HISTORIC DISTRICT COMMISSION

ADDITIONAL INFORMATION REQUEST

Application Number: HDC2025-00530

NAME: Lauren Thiel		COMPANY NAME: N/A	
ADDRESS: 913 Chicago Blvd	CITY: Detroit	STATE: MI	ZIP: 48202
PROJECT ADDRESS: 913 Chicago Blvd			
HISTORIC DISTRICT: Boston-Edison

Shutters before:

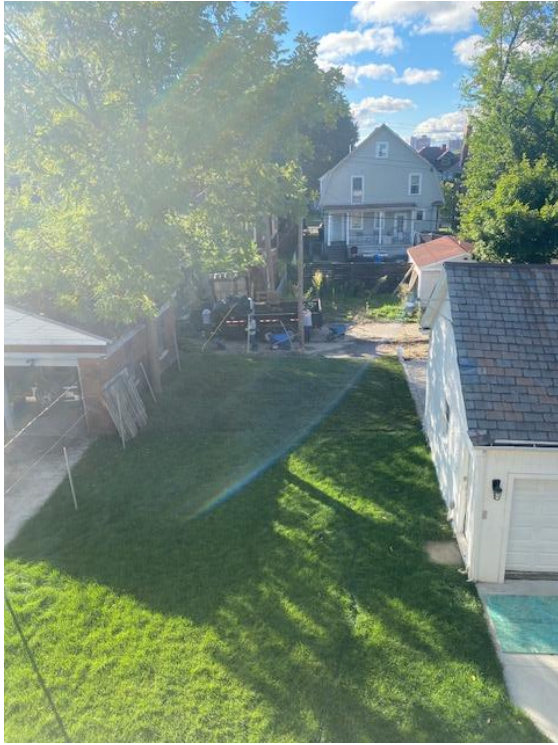
So please provide photos that show the house before the work began, and please include clear photos of the slate roof in place (not just the bare wood), the dormers before the roof replacement, the old porch pillars, the old shutters, and the porch before rebuilding. Then the commission needs to understand the nature of your proposal, so please provide product specs or cut sheets for the various products that were used, and please show clear pictures of the completed roof and dormers, the new porch pillars (what is their material?), shots from a bit back so the viewer can see the whole front of the house in one picture, and the completed porch. Also please share a scope of work for the porch that describes the work done and whether any historic bricks had been salvaged. The commission will need to compare the before and after photos to understand the work and see if it meets the Secretary of the Interior's Standards for Rehabilitation.

913 W. Chicago 1974

Shutters removed

(this was done prior to ownership or two owners ago)

(day of purchase, 3/31/2022)
